**REGULAR MEETING OF THE UNITED LAGUNA WOODS MUTUAL
ARCHITECTURAL CONTROL AND STANDARDS COMMITTEE**

**Thursday, January 17, 2019 – 9:30 a.m.
Laguna Woods Village Community Center Board Room
24351 El Toro Road**

DATE: January 17, 2019
FOR: Architectural Control and Standards Committee
SUBJECT: Variance Request: Mr. Roger Flinn of 126-D (Majorca, 8A)
Retain Modification to Previous Variance Requiring Common Area

22 EXISTING / DEMOLITION EXTERIOR ELEVATION - WEST
SCALE: 1/4" = 1'-0"

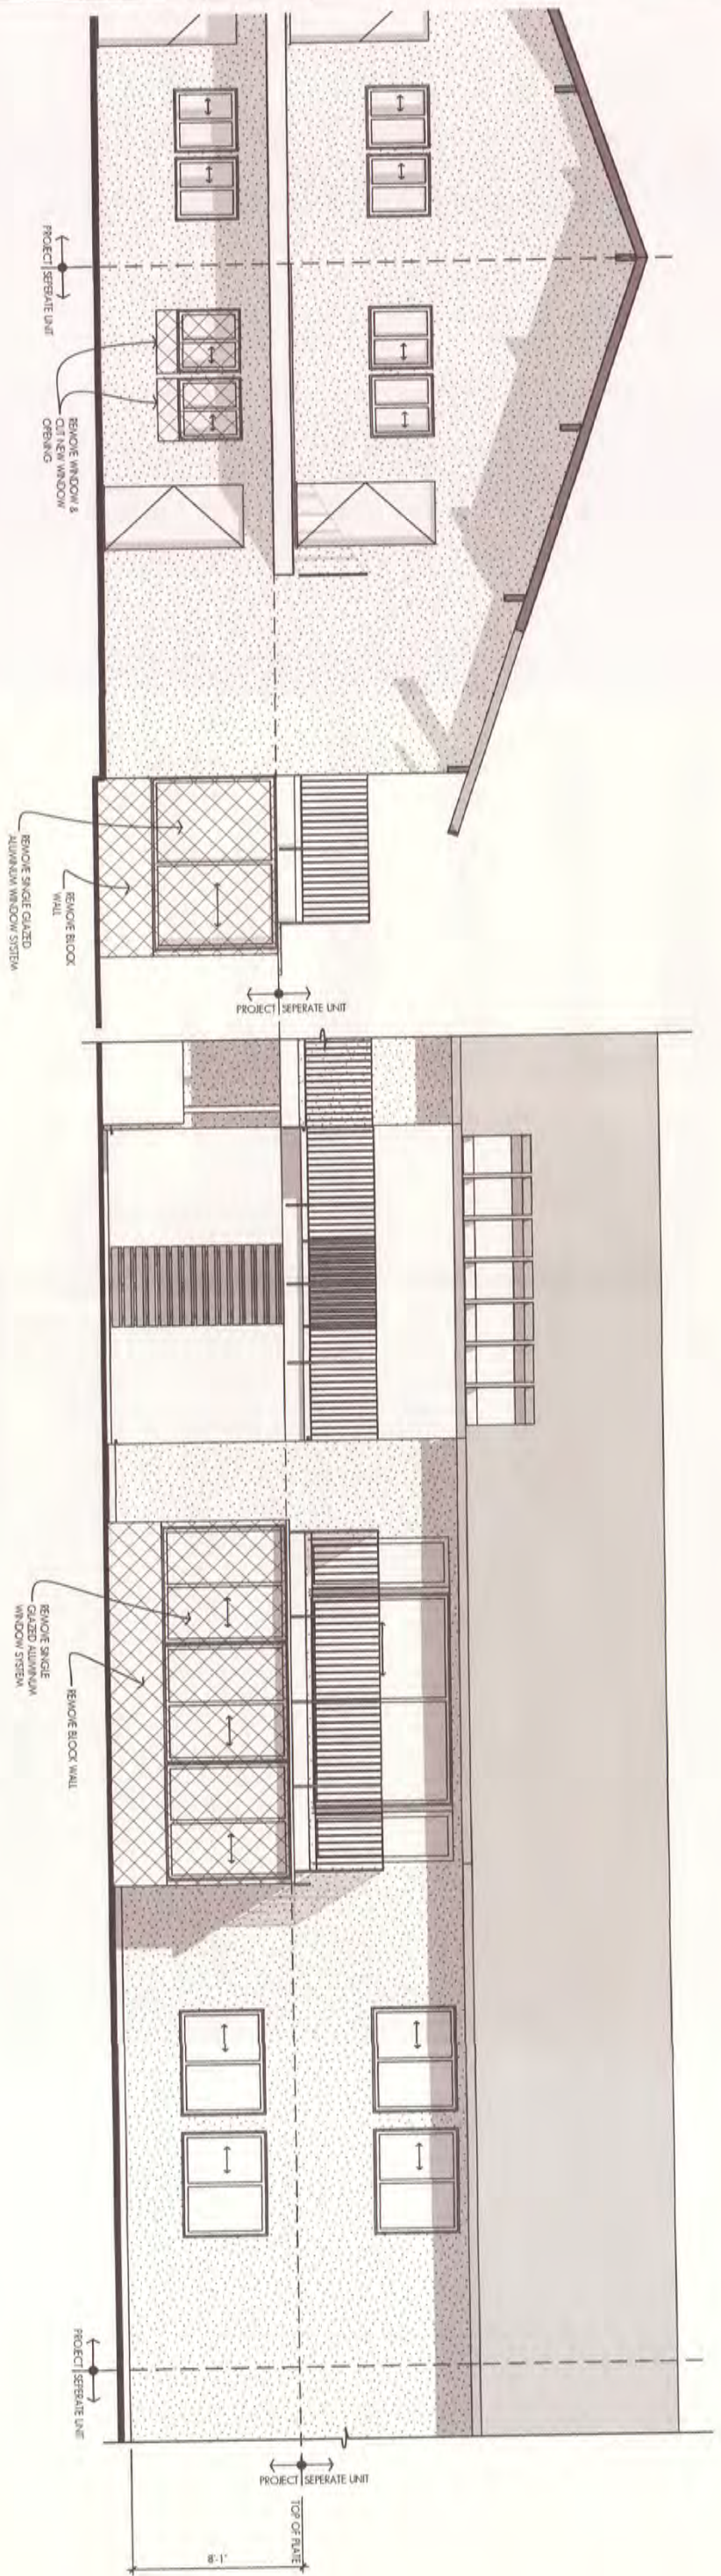
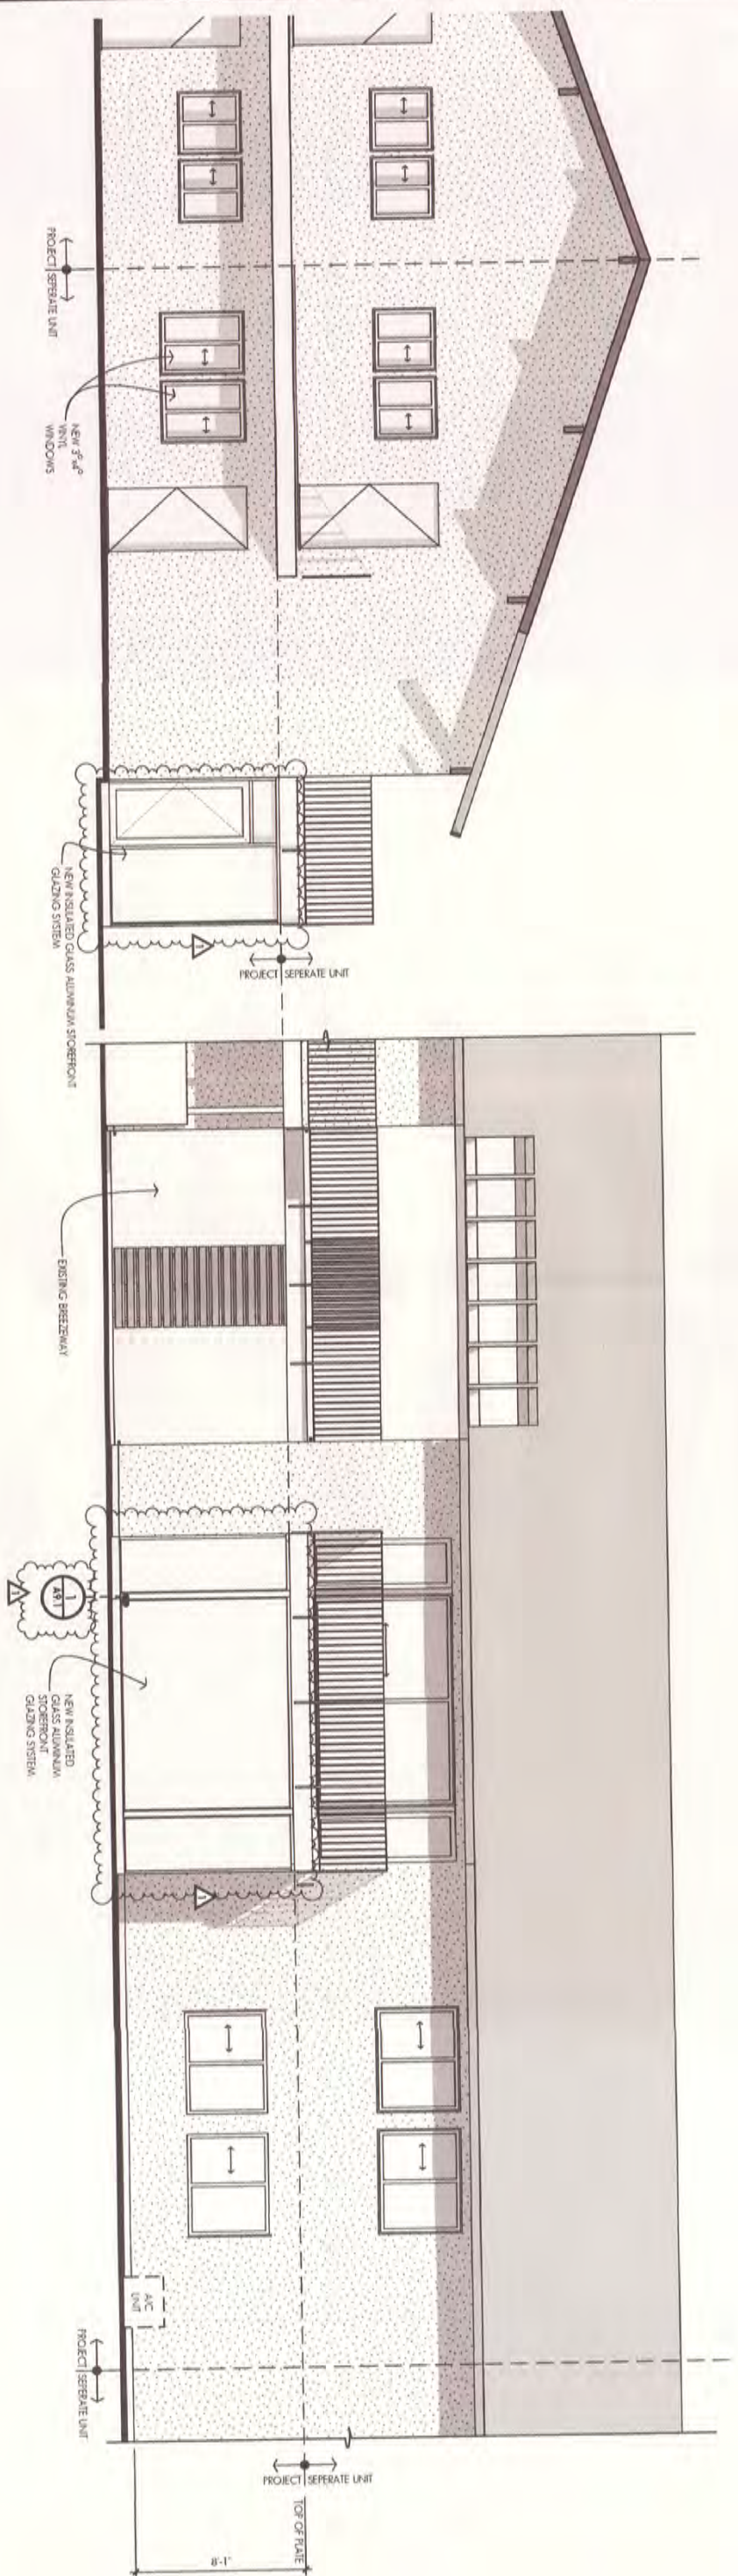
During a recent site inspection, Staff found windows were replaced with a single swing door, 2'8" wide by 6'11" tall on both east and west elevations of the alteration. For the alteration to meet local and state building codes, the new doors to the patio enclosure would require a concrete landing that would fall onto Common Area.

Based upon United Mutual Common Area Usage Policy, Staff recommends denial of doors on the alteration patio enclosure.

Staff recommends the Board deny the request to retain the doors constructed on the patio enclosure and approve keeping the topping slab as constructed, with the conditions as stated in Appendix A.

Attachment: 3

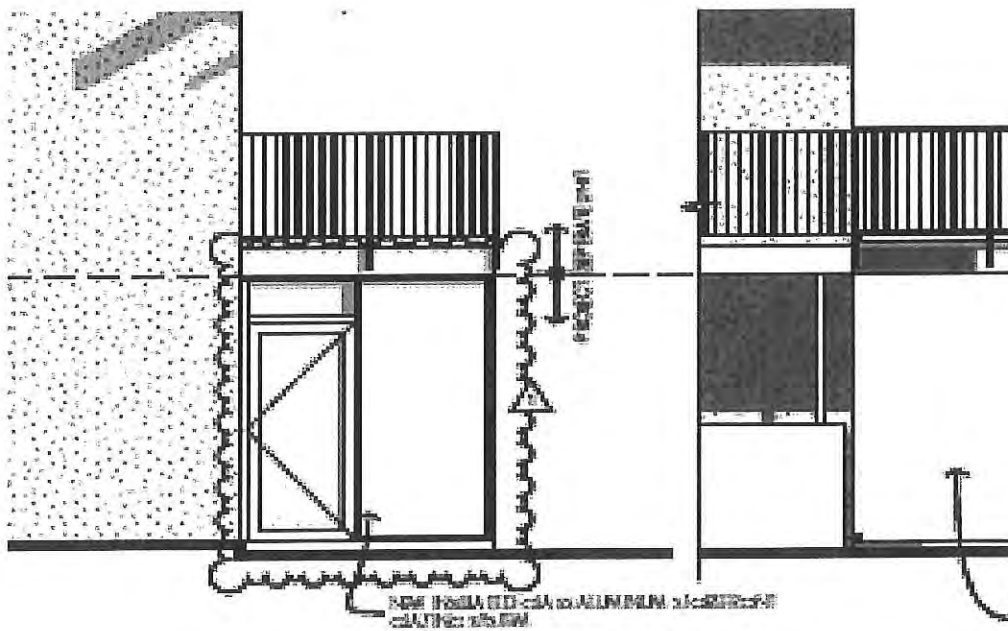
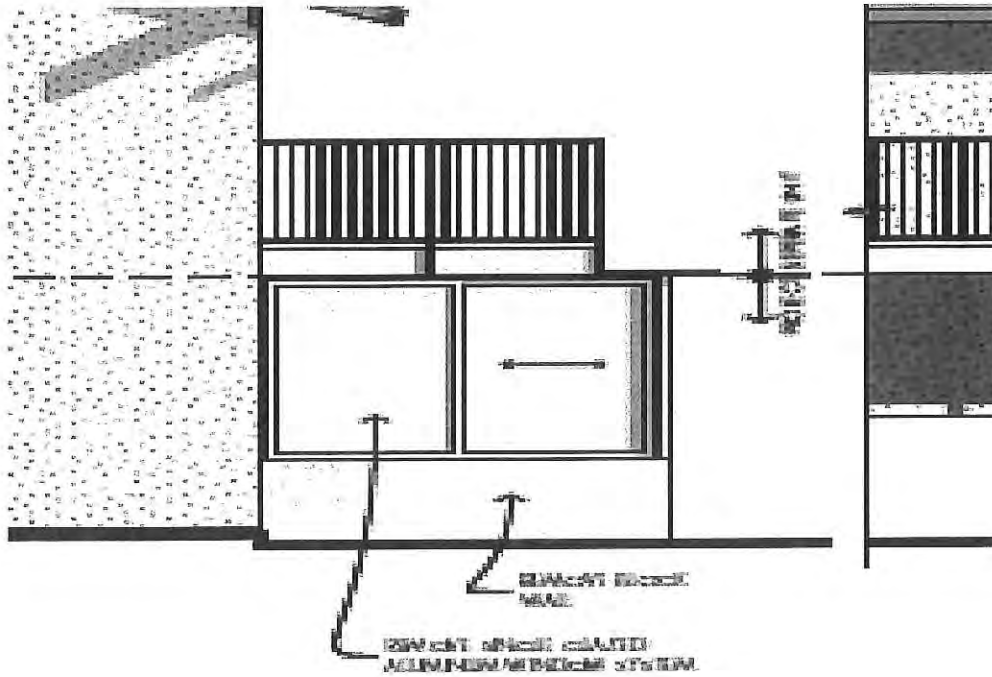
A second modification to the approved variance is the extension of the concrete topping slab, taking it to the end of the original patio slab (Attachment 3). Approved plans show the topping slab ending at the glazing; the original patio slab extends to the end of the designated patio area (Appendix B).

Due to the topping slab being located within the original designated patio area and the low grade of the surrounding landscape, Staff recommends approval to keep the extended topping slab with two additional conditions:

1. Topping slab shall be given a stucco finish on all exterior surfaces and painted to match the rest of building.
2. Prior to completion of Mutual Consent, Shareholder shall contact Landscape Division to review and install landscape to sufficiently restrict the view of the exterior topping slab from the street and walkways. All landscape modifications shall be at the owner's expense.
